Subject: Kiel Rear Cross Belt Extension Bracket Retrofit			
Field Change Program: Field Campaign	FCP Number: 490	Revision: A	Date: 10/13/2020
Coach Section: 03- Body	P/N: 03-11-2406		Type: Safety Recall

Ref. NHTSA Recall No.: 20V-578	Ref. Transport Canada Recall No.: N/A
--	---

Kiel NA
Procedure: Addition of Rear Cross Belt Extension Bracket
Rev. 0

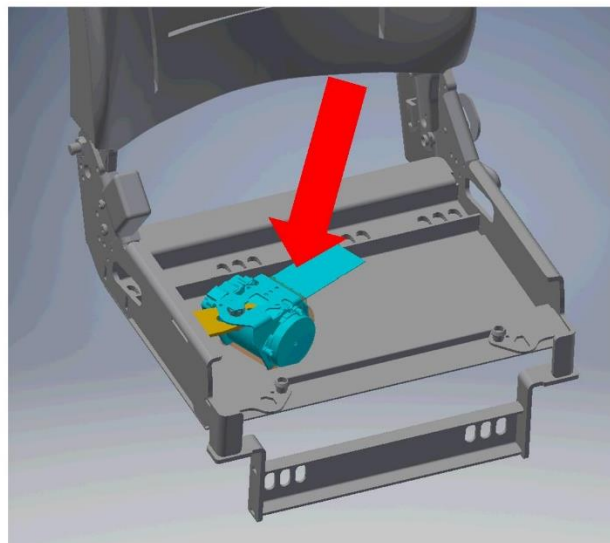
- 3.4. Remove belt retractor from chassis and dispose of hardware.

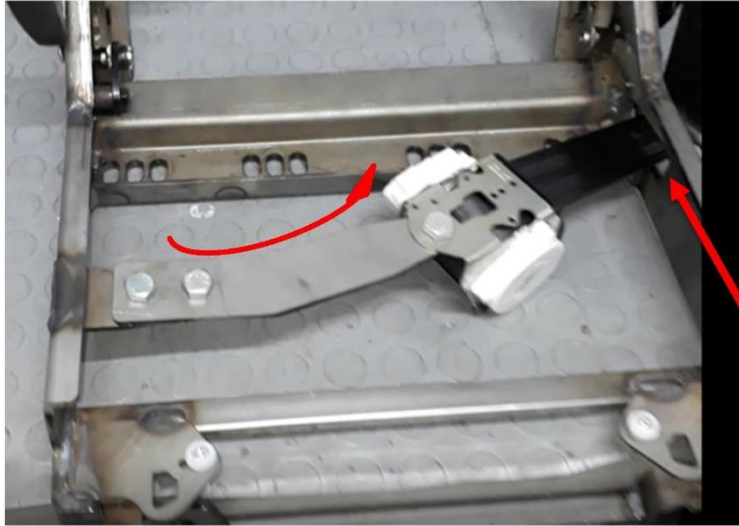
- 3.5. Install bracket (part number: N263110) as pictured below with “dog leg” facing rear of seat.
 - 3.5.5. S980200013 3ea. Bolt 7/16” -20 UNF.
 - 3.5.6. 3008067 3ea. Nut 7/16”-20.
- 3.6. Reinstall belt retractor as pictured below using new hardware provided by Kiel.

Webbing should NOT touch sides of slot.

- 3.7. Use Loctite number 242 on bolt threads.
- 3.8. Special notes:
 - 3.8.1. Make sure webbing angle is in line with the webbing slot and ring on chassis frame.
Webbing should not touch sides of slot.
 - 3.8.2. Do not roll or twist webbing.
- 3.9. Torque all 3 hardware sets to 28Nm or 21 ft. lbs.
- 3.10. Torque mark the nuts.
- 3.11. Replace seat cushion.
- 3.12. Test as per: Procedure: 3-Point Lap and Shoulder Belt Function
